Design Review Board Meeting

**111 WEXFORD CLUB
DRIVE
FINAL REVIEW
AUGUST 13th, 2024
DRB-001088-2024**

**111 WEXFORD CLUB
DRIVE
PROJECT NARRATIVE
&
WEXFORD HOA
APPROVAL
&
DRB COMMENTS AND
RESPONCES**

Project:	Project No.
Wexford Clubhouse Renovations & Additions	24001
111 Wexford Club Drive	Date: 5/6/2024
Hilton Head Island, SC 29928	Submittal: HHI Conceptual Review

1 WEST ELEVATION
3/16" = 1'-0"

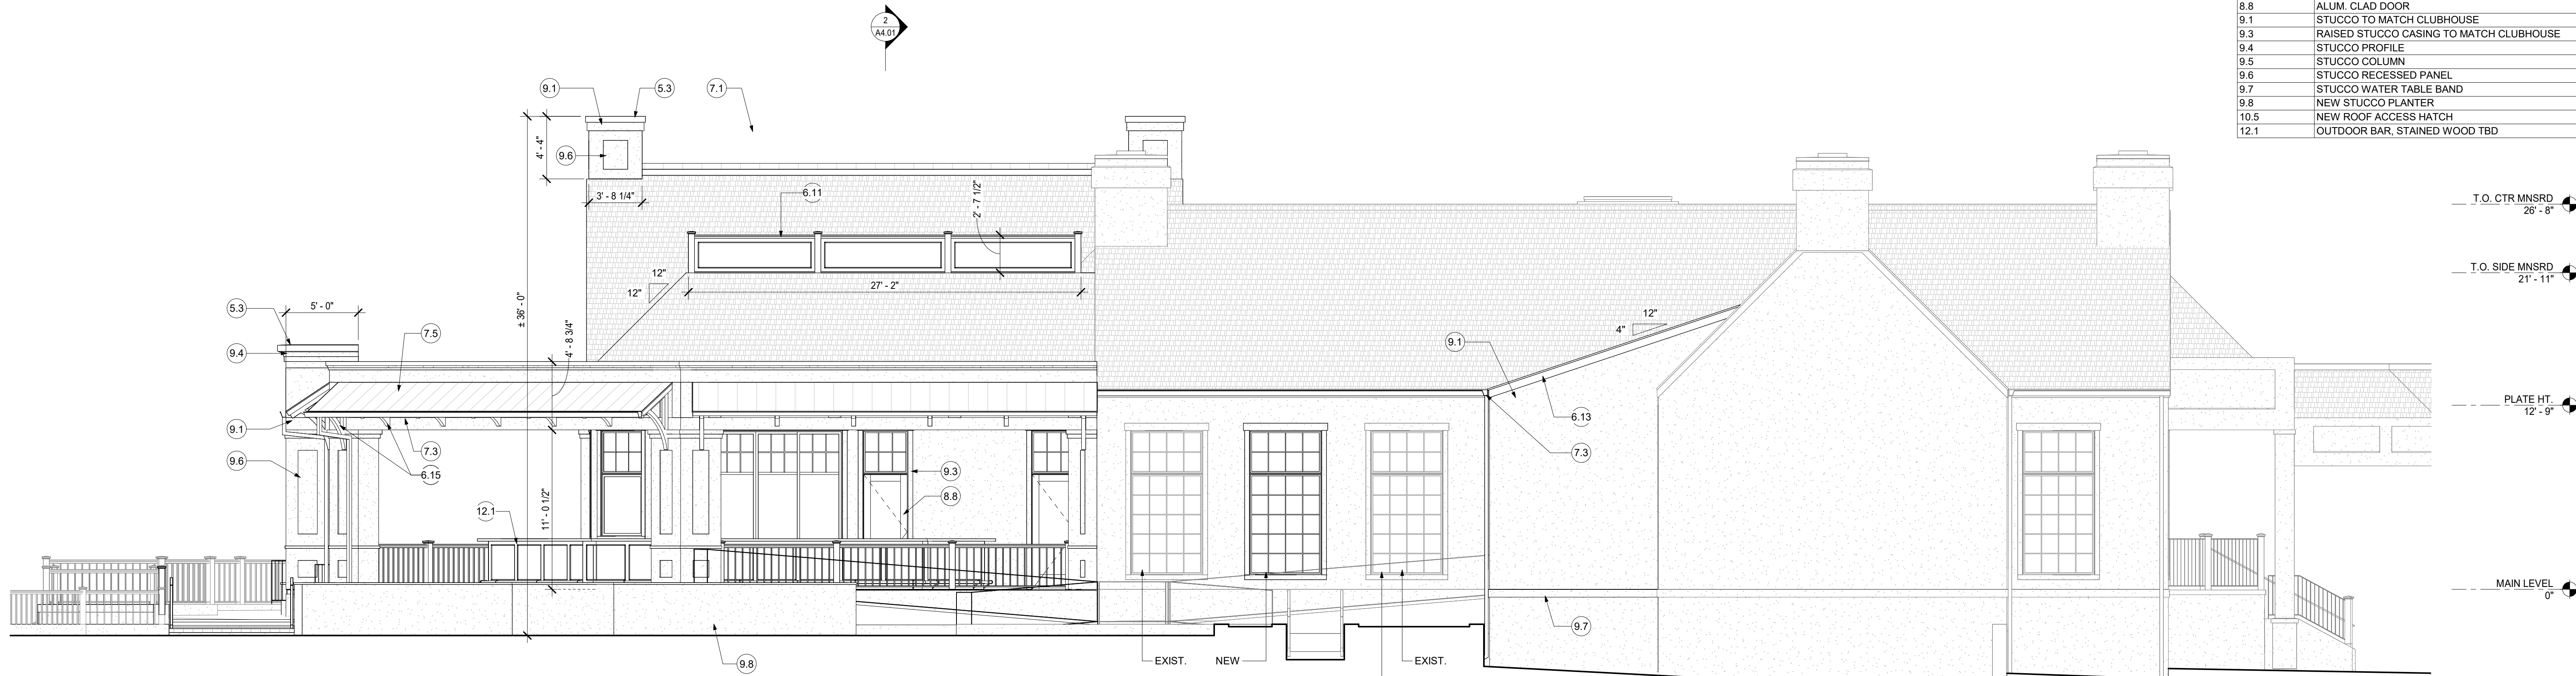
- a. **Narrative:** This has been updated on the landscape plans.
5. **DRB comment:** "Study the scale of the small metal roofs. Associated primarily with the rear near the porch."

- a. **Narrative:** The small metal roofs have been changed to wood framing supported by thick timber brackets. The brackets at the ends of the roofs extend down the wall/pilaster, and the intermediate brackets are mostly under/behind the roof (when seen in an elevation drawing). We appreciate this comment and think this is a good change to keep the detailing more in scale with the rest of the composition. These can be seen in the elevations, details, and renderings.

CLUBHOUSE AREA LANDSCAPE PLAN

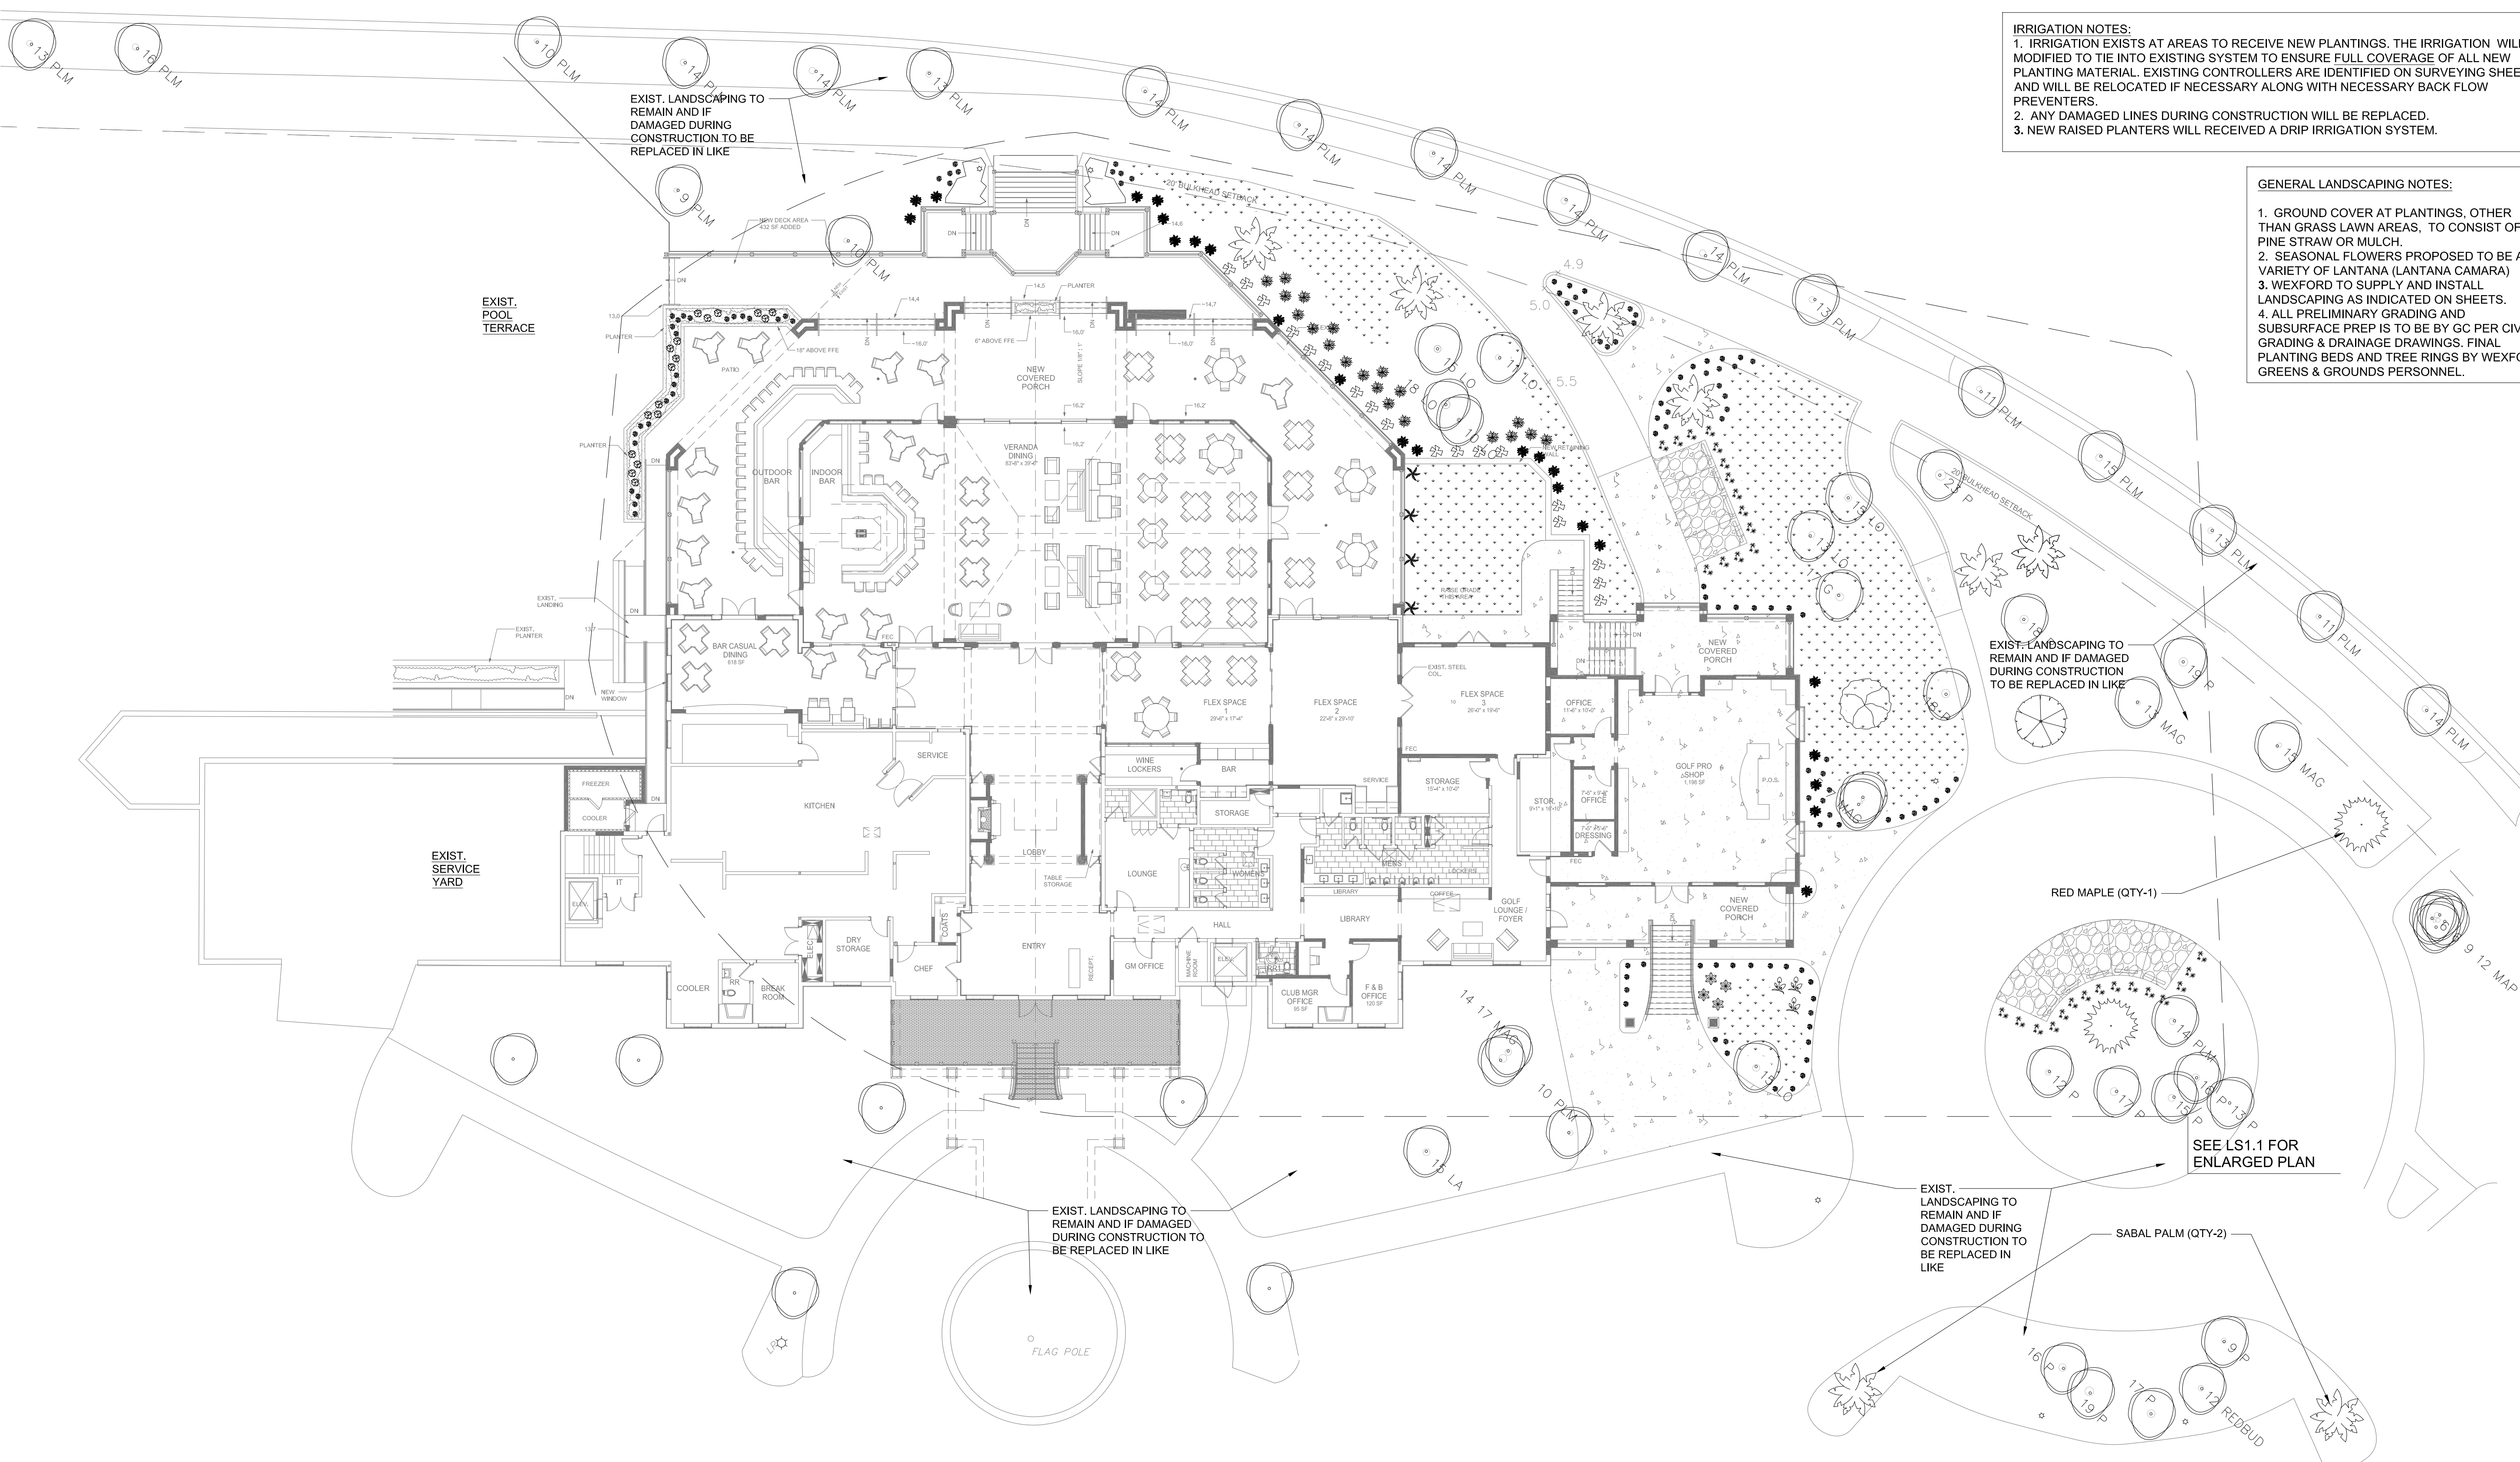
3. **DRB comment:** "Decrease the spacing and coverage associated with the foundation plantings and appropriately scaling those depending on the associated walls."

- a. **Narrative:** This has been updated on the landscape plans.
4. **DRB comment:** "The expansion of landscape coverage to mirror on the backside, on the harbour side of the building, to the pool area and the front side, beyond on either side of the expansion of the pro-shop. If materials are to be kept, it needs to be shown."

1 ROOF PLAN
3/16" = 1'-0"

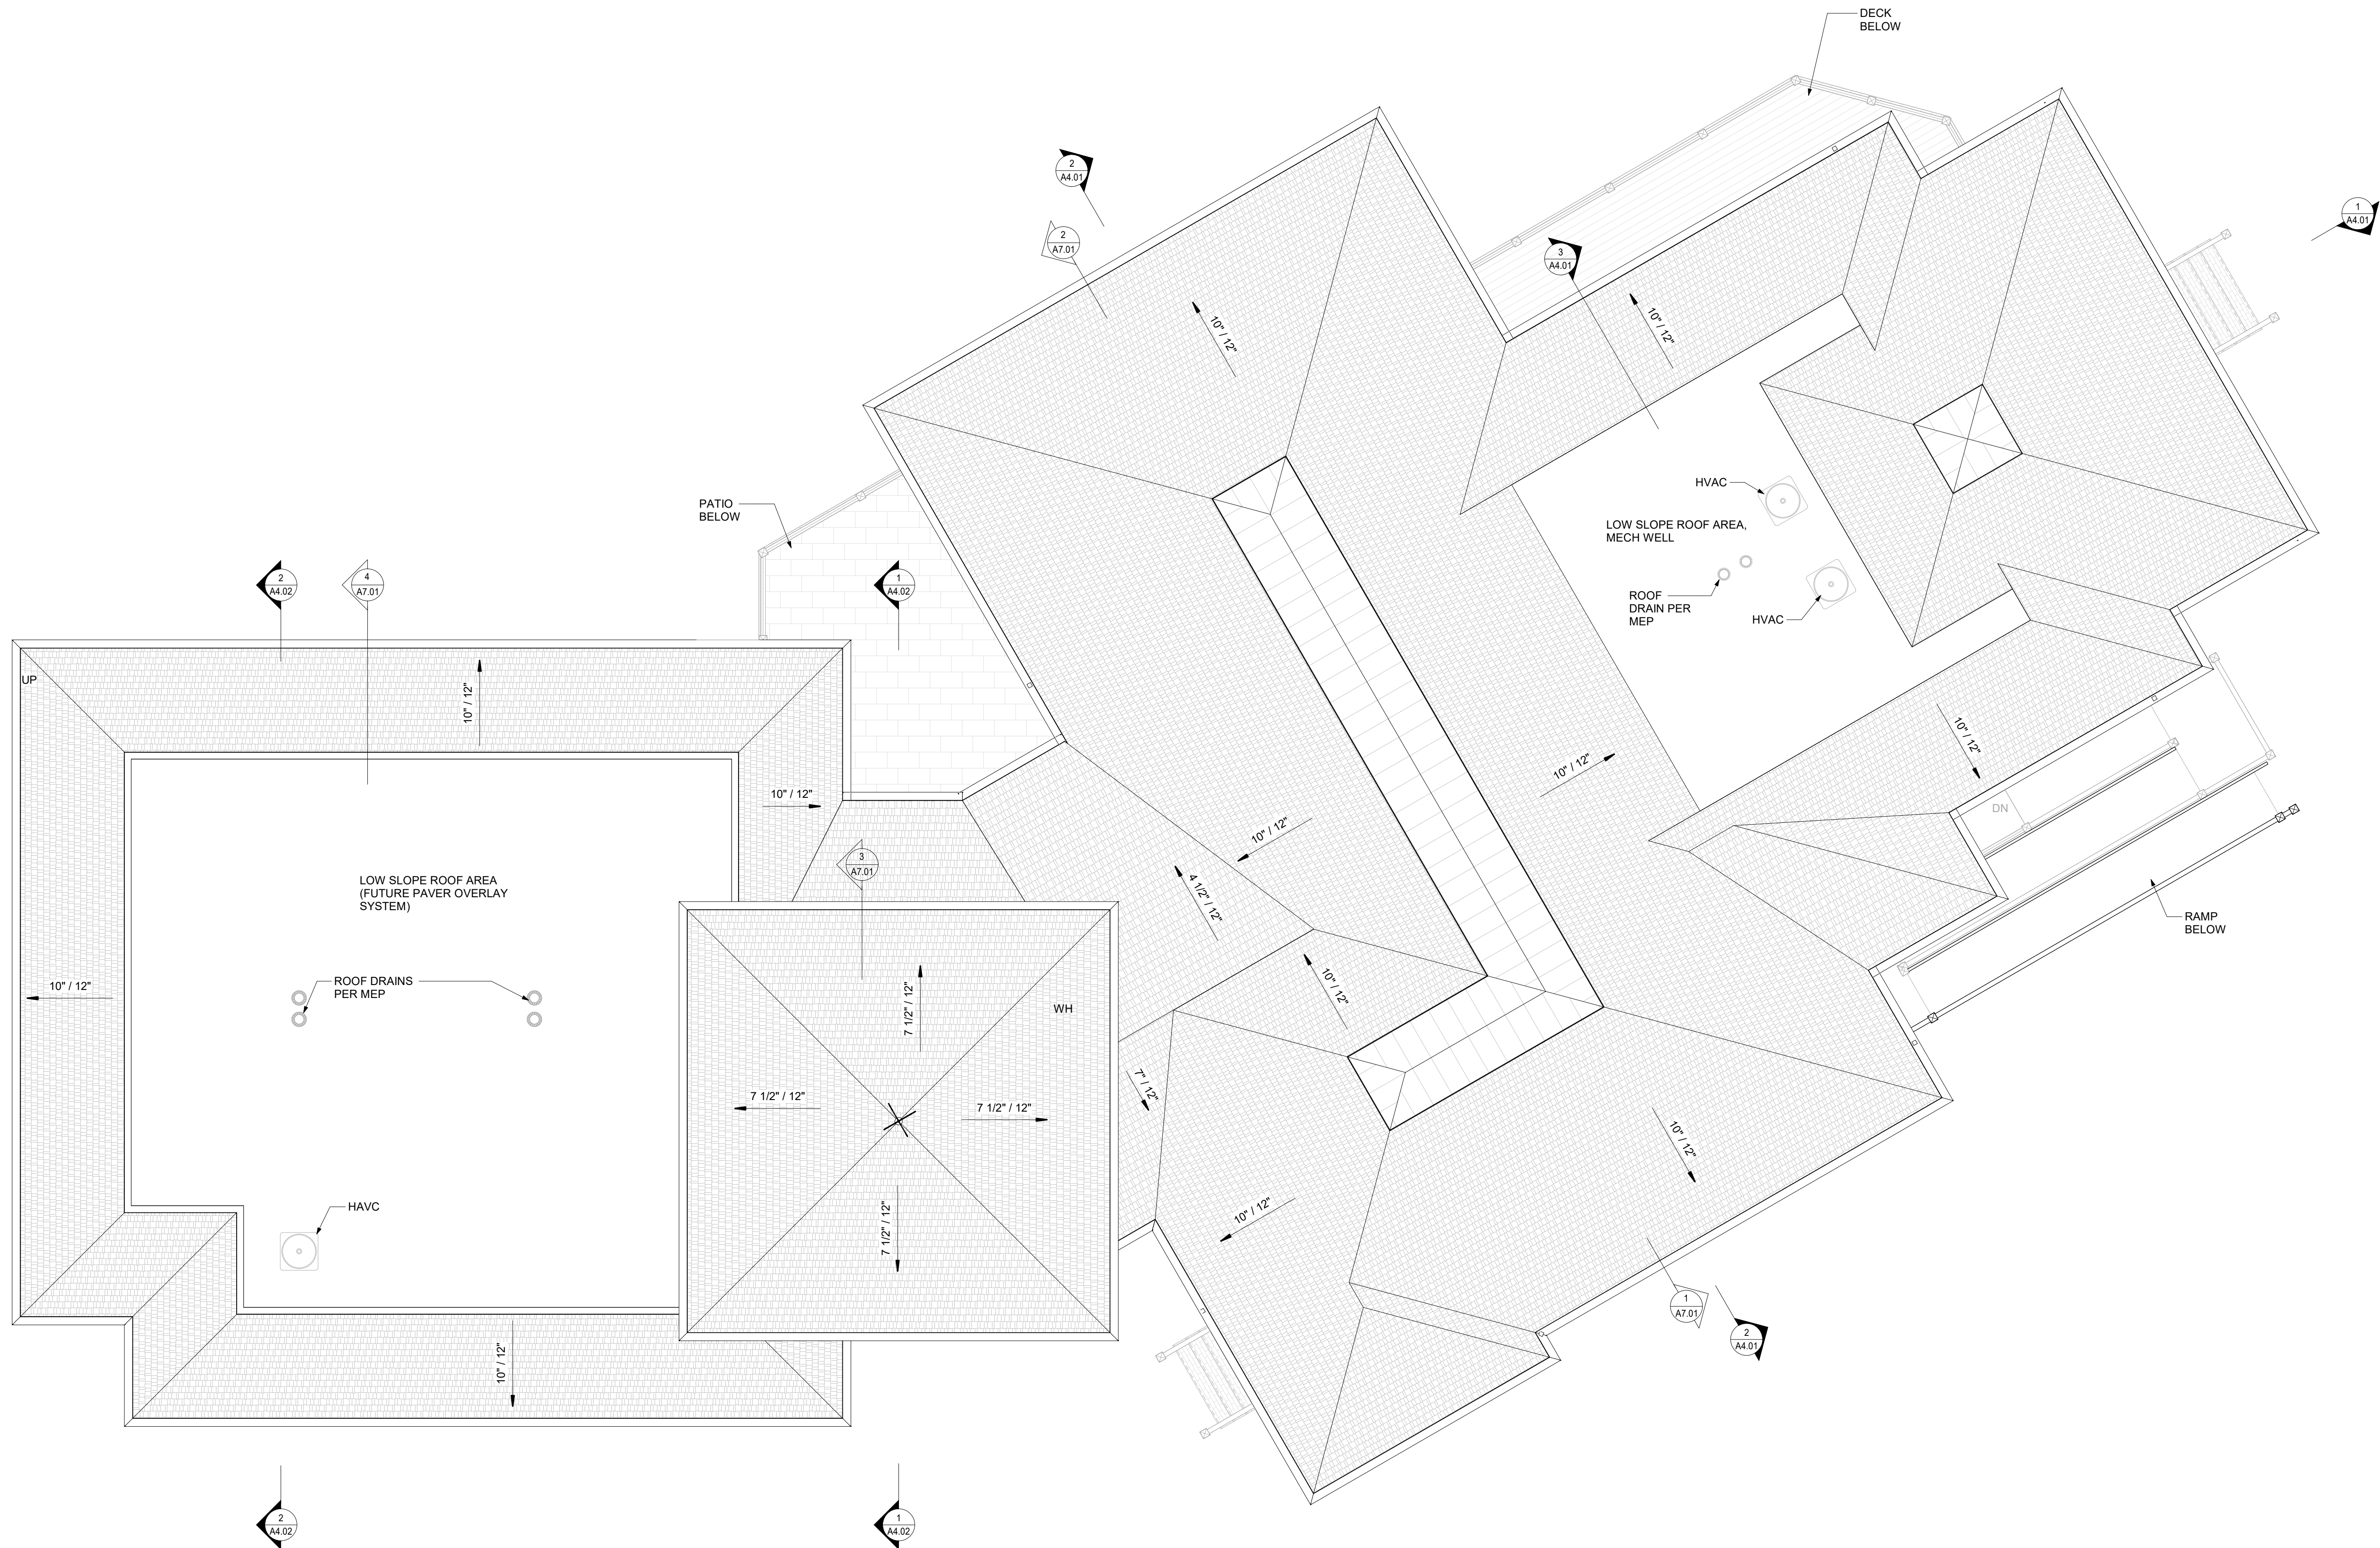
1. Sample board, revised landscape plan, lighting plan, prominent details, final floor plans, and final elevations are included in the submittal.
2. **DRB comment:** “Submit a utility plan that indicates the location of equipment and the screening of it.” And “To verify the service yards and the exhaust hoods reviewed and provide details”

- a. **Narrative:** All of the HVAC equipment will be located on the roof in deep roof wells. The sidewalls of the wells completely hide the HVAC units. There will be no equipment on the ground that will need screening. This is shown on the roof plan and building sections.
